Annex A1: Note to Readers

In April 2015, Treasury Metals Inc. (TMI) submitted an Environmental Impact Statement (EIS) for the proposed Goliath Gold Project (the Project) to the Canadian Environmental Assessment Agency (the Agency) for consideration under the Canadian Environmental Assessment Act (CEAA), 2012. The Agency reviewed the submission and informed TMI that the requirements of the EIS Guidelines for the Project were met and that the Agency would begin its technical review of the submission. In June 2015, the Agency issued a series of information requests to TMI regarding the EIS and supporting appendices (referred to herein as the Round 1 information requests). The Round 1 information requests included questions from the Agency, other federal and provincial reviewers, First Nations and other Aboriginal peoples, as well as interested stakeholders. As part of the Round 1 information request process at the request of the Agency, TMI has consolidated the responses to the information requests into a revised EIS for the Project.

The enclosed document provides the final responses from 1 to 265 of the Round 1 information requests included as Annex A3. For ease of cross-referencin

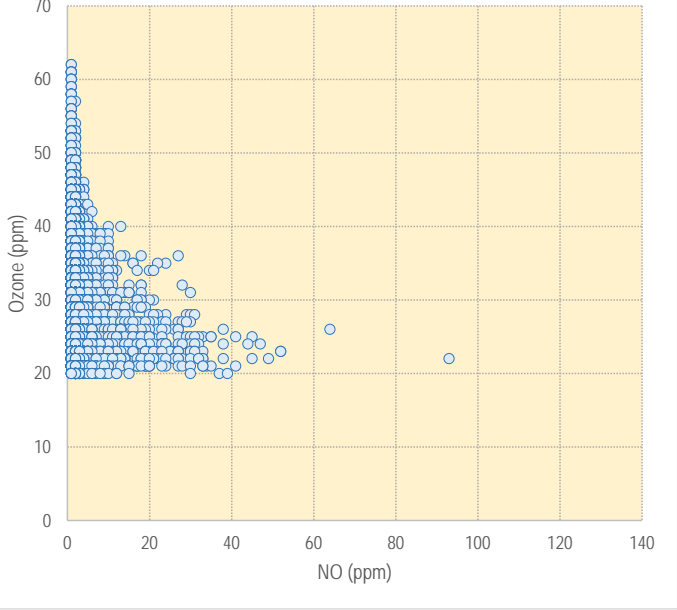
Conifer	779.08	16.09	1.18																																																																																																																																																																																																																			
Deciduous	697.04	7.30	0.79																																																																																																																																																																																																																			
Successional	226.93	3.20	1.03																																																																																																																																																																																																																			
Upland	95.53	.091	0.00

Wetland	401.64	14.07	0.33
